**SAFETY
RECALL**

SR19-04A

DATE :	June 2019	SECTION :	14 STEERING
SUBJECT:	DRAG LINK REPLACEMENT

Revision: A

Figure 1: Recalled draglink with turnbuckle and two clamps.

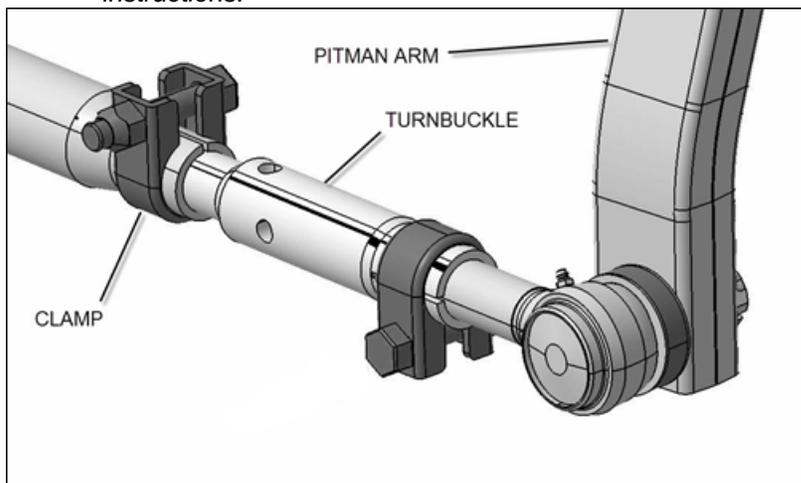
On the vehicles involved equipped with I-beam axles, cracks can occur and propagate in the steering draglink turnbuckle under certain conditions. If the cracks start to propagate, over time it may extend inward to a point where the turnbuckle may fracture.

1. This recall involves a former draglink design with a turnbuckle near the pitman arm.(Figure 1)
2. Open the front service compartment and pull on the front bumper release. The pitman arm and steering draglink can be found on the driver's side.
3. The recalled draglink is identifiable by the presence of a *turnbuckle* and *two clamps* in the section nearest to the pitman arm. (Figure 1)
4. If it is confirmed your vehicle has the recalled draglink (Figure 1), you may proceed to the replacement.
5. If your vehicle does not have the recalled draglink design, please read further for *additional instructions*.

Inspect the draglink and if required, replace the complete draglink by an improved part.

Figure 2: Improved 660699 draglink

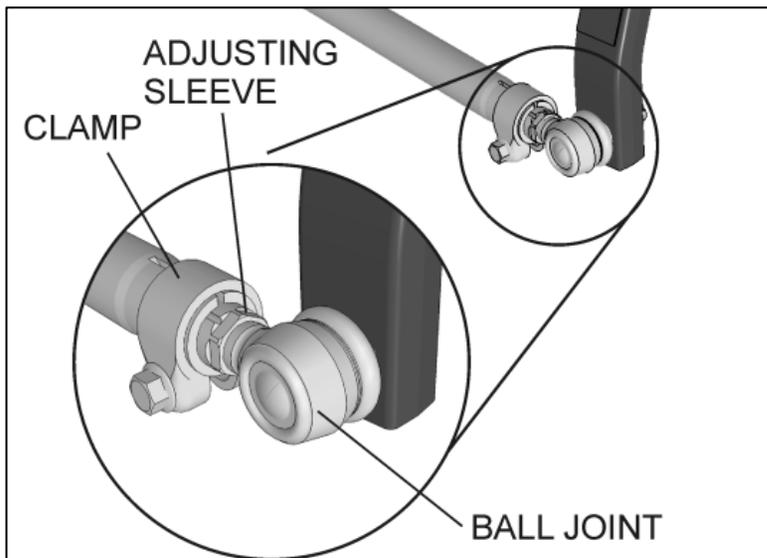
The improvement can be confirmed by the presence of an *adjusting sleeve* and a *single clamp* in the section nearest to the pitman arm. (Figure 2)

If the vehicle already has this draglink, this is the improved part being installed in the recall. *You do not have to perform the replacement.*

FIGURE 3

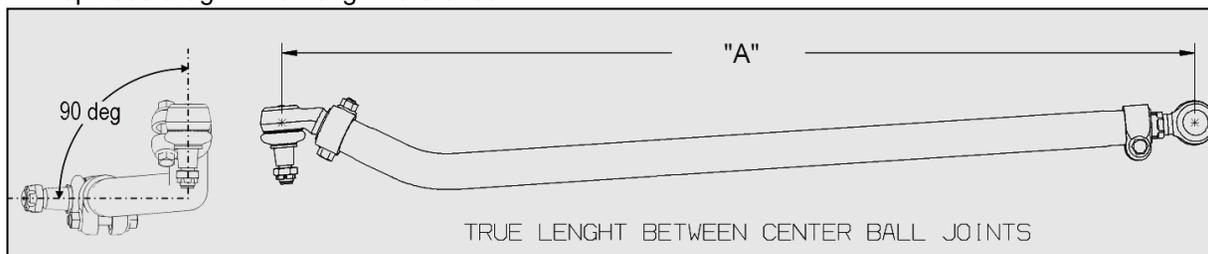
6. Check if the pre-adjusted length of the drag link is correct. To do so, try to install it between the steering arm and the pitman arm. If the length is not adequate, it must be adjusted to the required length. Use dimension "A" to adjust the length of the replacement drag link or you may use the replaced drag link for length reference.

Length A = 52" 3/8" ± 1/16" (1330mm ± 2mm)

FIGURE 7: NOTE THE VERTICAL ORIENTATION OF THE CLAMP BOLT AT THE KNUCKLE END AND ON WHICH SIDE THE NUT MUST BE POSITIONED

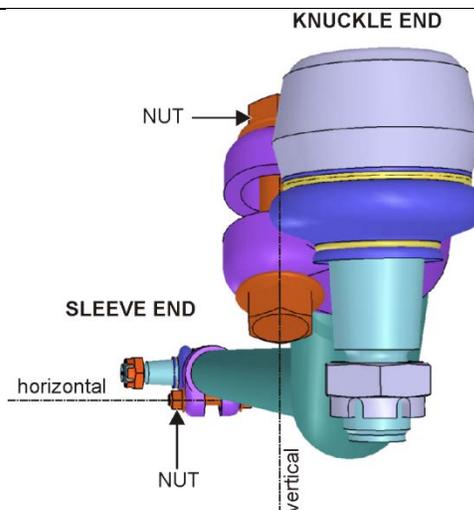
10. To prevent interference between the ball joint clamp bolts and other components of the steering system, the clamp bolt must be positioned vertically as shown on FIGURE 7. **Tighten the clamp nut to 118-133 lbf-ft.**

Do not re-use clamp hardware.
Bolt and nut should be replaced every time they are unscrewed. Use collar assembly 660018.

FIGURE 10

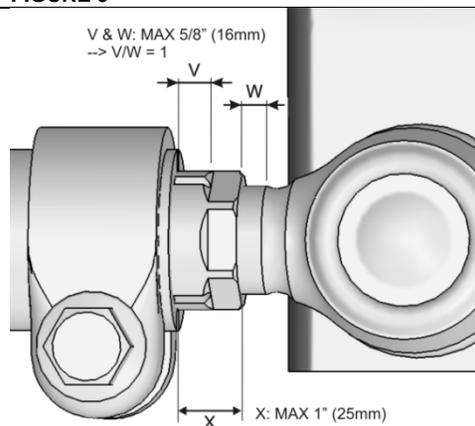
Do not exceed the following maximum thread lengths and values.

- Max dimension **V** : 5/8" (16mm) ± 1 thread pitch
- Max dimension **W** : 5/8" (16mm) ± 1 thread pitch
- Max dimension **X** : 1" (25mm)
- Dimension **V** and **W** should be equal. ($V/W = 1$)

FIGURE 12: NOTE THE HORIZONTAL ORIENTATION OF THE CLAMP BOLT AT THE SLEEVE END AND ON WHICH SIDE THE NUT MUST BE POSITIONED

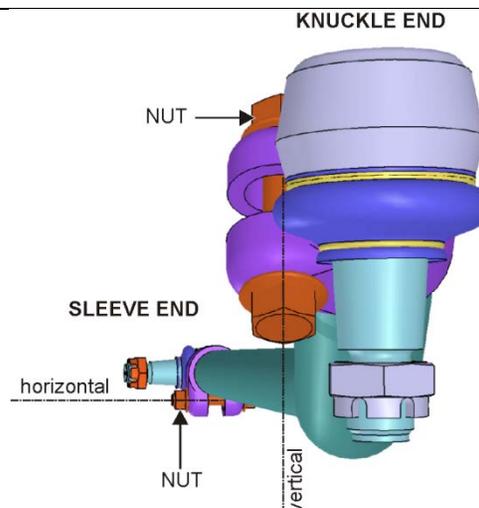
13. Adjust sleeve to the values of FIGURE 11.
14. Once the proper length adjustment is done, tighten the front end ball joint clamp. To prevent interference between the ball joint clamp bolts with other components of the steering system, the clamp bolt must be positioned horizontally as shown in FIGURE 12. **Tighten the clamp nut to 118-133 lbf-ft.**
15. Apply a torque seal mark
